Davis-Besse Nuclear Power Station, Unit No. 1  
Docket No. 50-346, License No. NPF-3  
Response to Request for Additional Information Regarding License Amendment  
Request to Adopt National Fire Protection Association (NFPA) Standard 805  
(CAC No. MF7190)

Response to Request for Additional Information  
Page 1 of 90

Figure 1. Emergency Diesel Generator Circular Logic Breaks

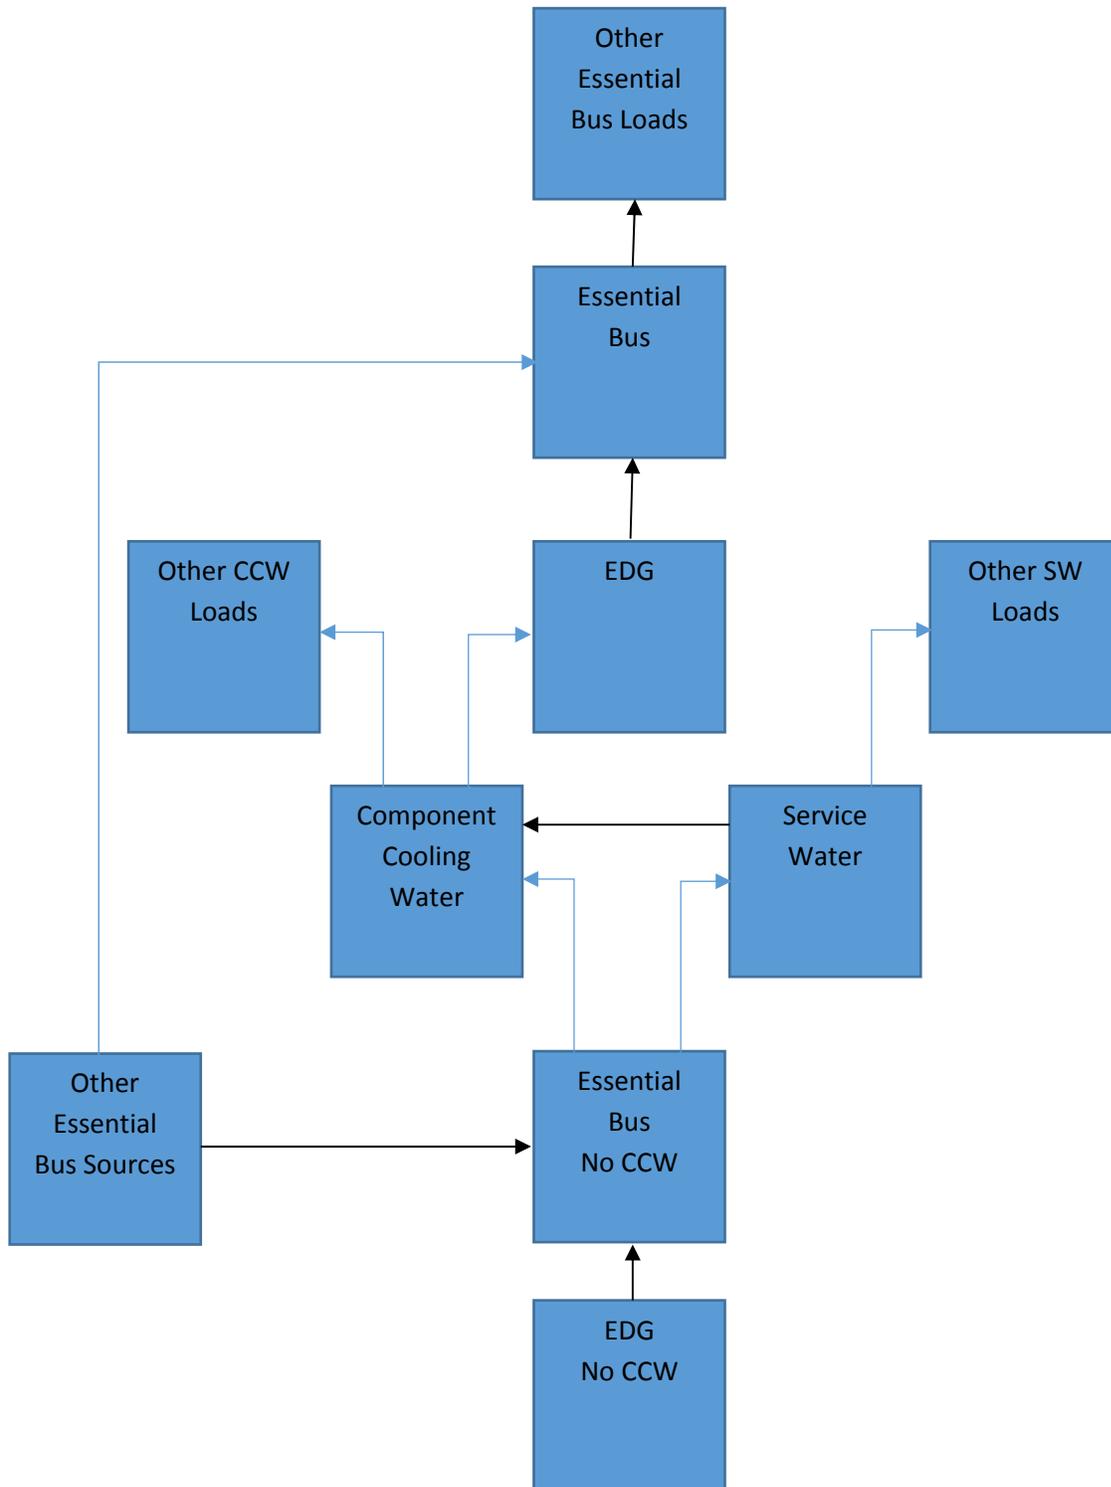
**F&O LE-E4-01 states that it was difficult to determine if circular logic was appropriately modeled, and the LAR does not provide additional details on how circular logic was modeled. Describe how circular logic loops were modeled. Provide the bases (e.g., timing associated with the particular equipment) for breaking the circular logic and justify that the treatment does not exclude important risk contributors, such as dependent failures.**

To answer the larger question on circular logic, the following provides a better discussion as to how circular logic was addressed. Circular logic or a logic loop is defined as the infinite circulation of supporting relations due to their mutual system dependencies in the fault tree analysis. An example is the CCW cooling to the emergency diesel generators (EDGs), and the circular dependence of the CCW pumps on power (from the EDGs following a LOOP). The computer program CAFTA has a tool to identify logical loops that may exist in a fault tree, and loops must be broken prior to quantification. The approach used to break these circular logic loops was to develop special gates for the last level of support, without the circular dependence, which then feed through the systems causing the loop. Conceptually, if system A and system B form a logical loop, a special gate containing all failures of system A except for its system B dependencies was created. The special system A gate then serves as the dependency to system B. System B is then linked into the system A logic that serves the rest of the fault tree. In this way, all dependencies are maintained and no risk contributors are lost in the process. All logic loops were broken in this manner. For further clarity, some examples from the model are described below:

For the EDG cooling logical loop, a special EDG gate was developed that does not include CCW cooling dependencies but does include all other EDG failure modes. This gate supports a special gate that represents the loss of its associated essential bus (C1\_41). The special essential bus gate is then used for the power dependencies for service water (SW) and CCW. The SW and CCW trees then provide the cooling support for the EDG trees that support the power dependencies for all trees other than SW and CCW. Timing is not used as the basis for this process. Provided that offsite power is not available, any failure of an EDG would fail its associated CCW and SW trains and their loads, and any failure of CCW and SW equipment that supports an EDG will fail the

associated EDG and its loads. Figure 1 illustrates how the EDG logical loops were broken.
